**PETITION FOR DECLARATORY STATEMENT
BEFORE THE FLORIDA DEPARTMENT OF FINANCIAL SERVICES**

Case No.: 104163-09-FM

Waldrop Center Office Building – 28100 Bonita Grande Dr. Bonita Springs, FL 34135

RE: Waldrop Center Office Building, 28100 Bonita Grande Drive, three-story building

Exhibit A 1-1

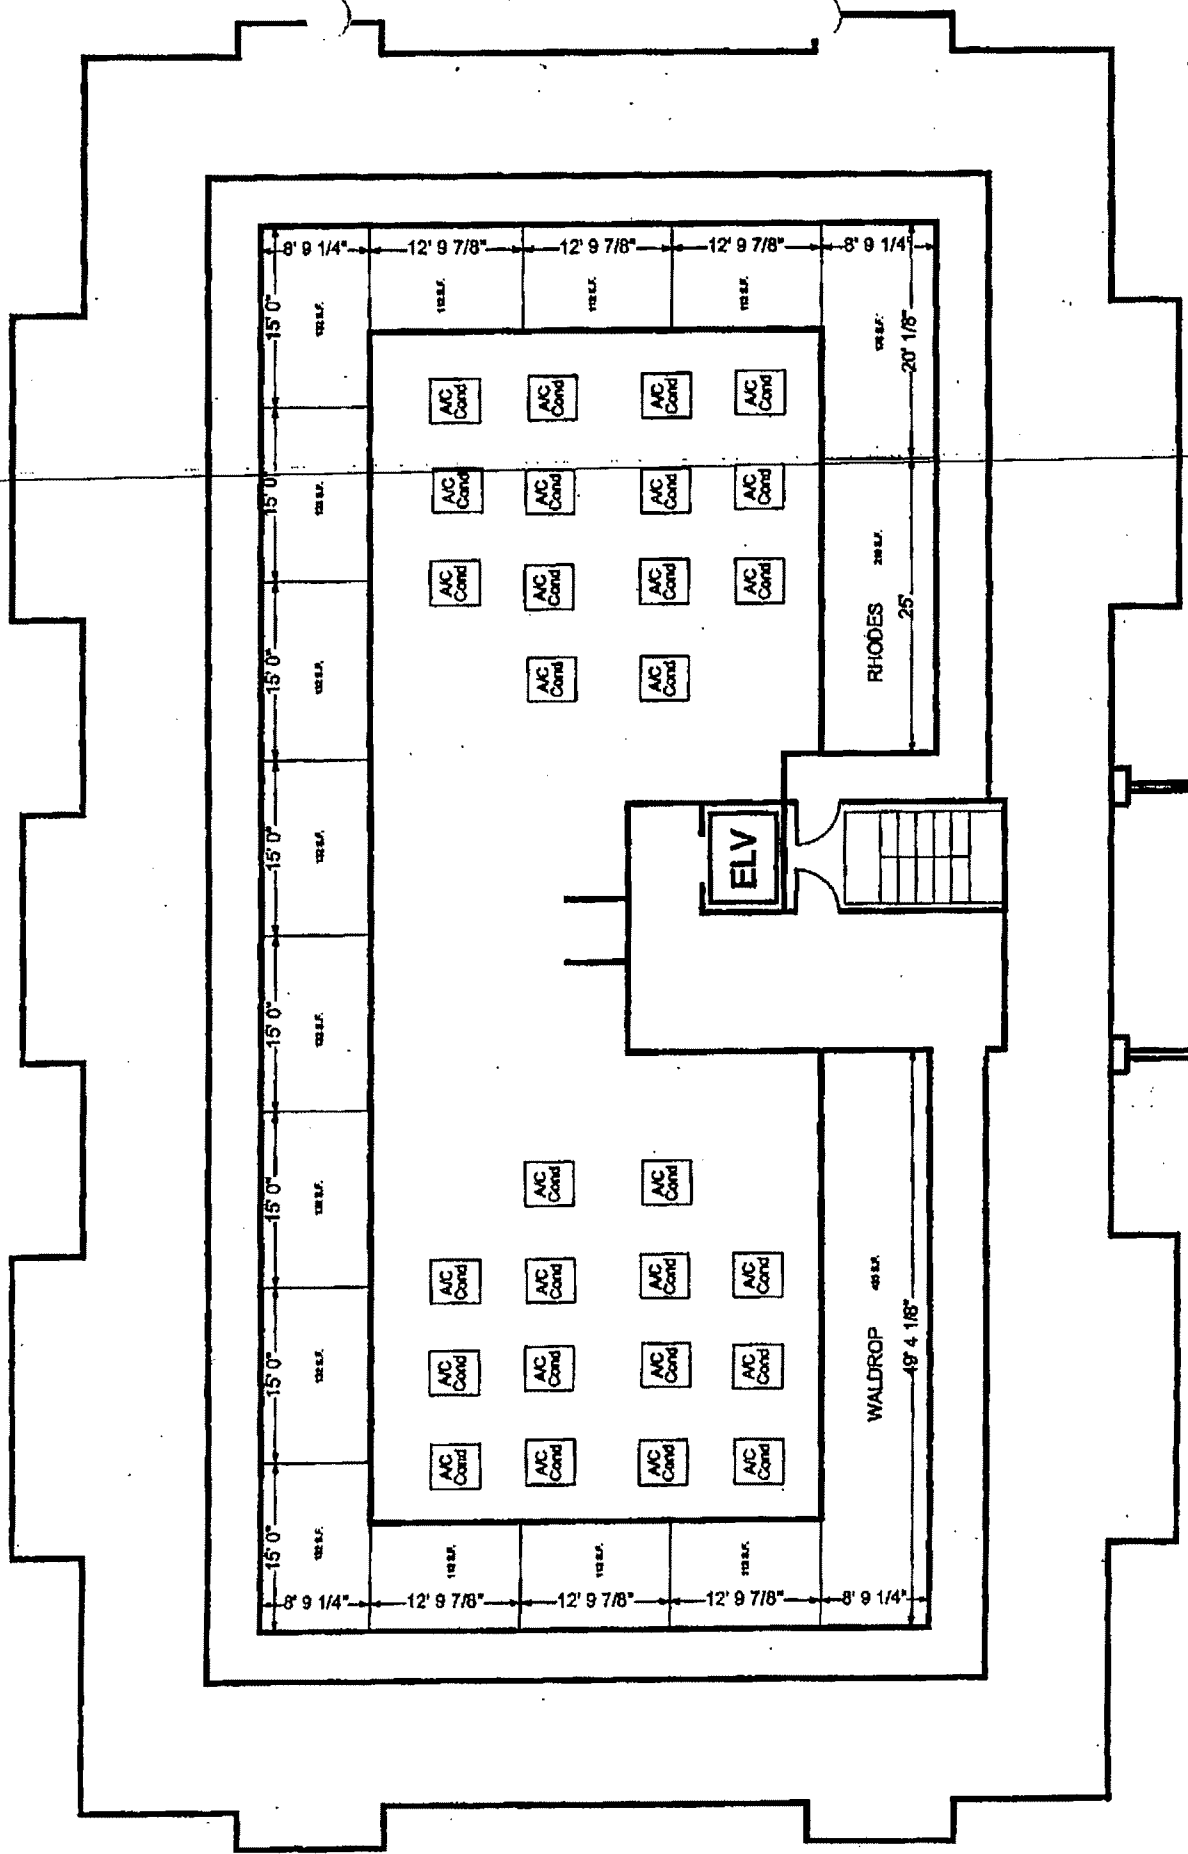
2. From a review of Exhibit A, does the single stair (means of egress) with two exit doors comply with code section FFPC NFPA 101 38.2.4.1?

The attic area is only accessible to one means of egress (stair), and not two separate means of egress as required by Code. The two doors on the existing stair does not count as two separate means of egress as defined by FFPC NFPA 101 3.3.151, but would be two separate exit doors into one means of egress that discharges out of the building.

The Code requires two Means of Egress that are continuous and discharges to the public way. Therefore, in order to convert the attic space into another floor that would be used for incidental storage to the Business Occupancy, another separate Means of Egress needs to be provided. Also, please keep in mind that there other applicable Fire or Building Codes that would apply here if the attic space is converted into another floor.

The attic space of your building cannot be used for incidental storage to business occupancy (your building) because there are not two separate means of egress (stairs) provided on that level. If you decide to add another separate means of egress (stair), then I will discuss the other applicable Fire Codes that will apply. Please keep in mind that the Building Code has applicable codes that would also apply, and can only be enforced by the Building Official.
